Comment 1 from Dan and Arnaldine Aires:

We have reviewed (to the best of our ability) the Expanded Initial Study for the bike lane project dated June 2024, and have the following questions we hope you can help us with.

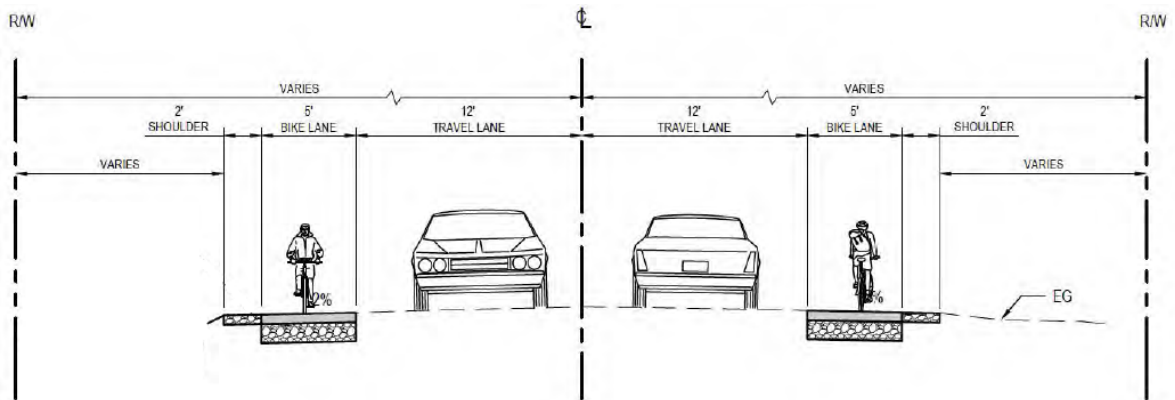
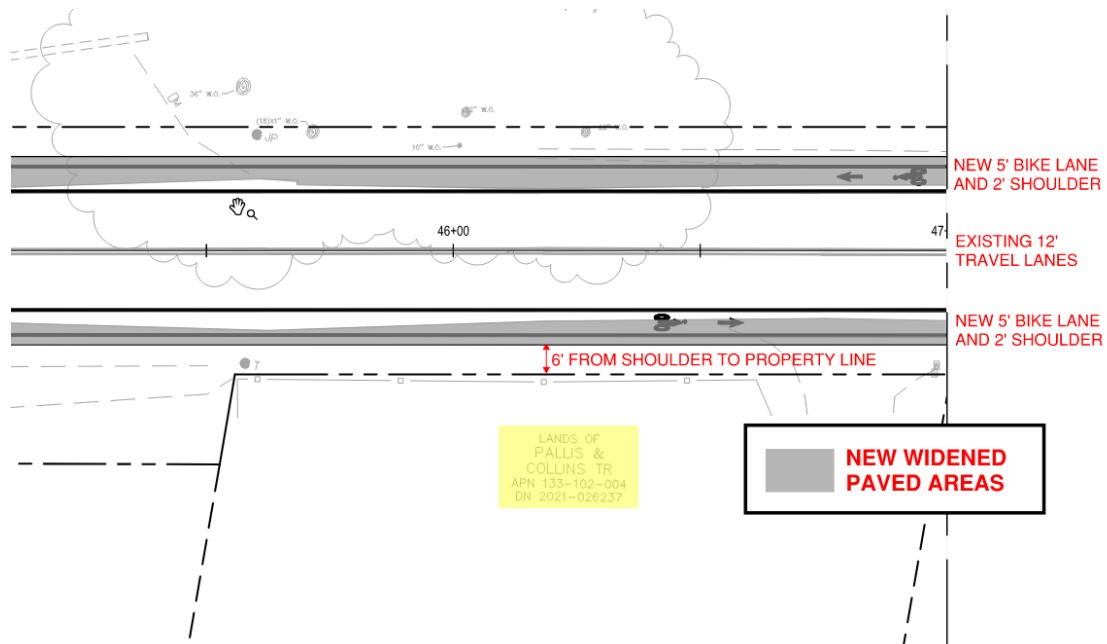
Chris - I am a homeowner on a portion of Arnold Drive that will be affected by this project. Rather than wading through the volume of material on this matter, can you either provide me or direct me to materials that would show me what is currently proposed along our property line with Arnold Drive? My address is 16657 Arnold Drive, between Don Timito and Loma Vista.

Response: please see below graphic depicting your frontage.
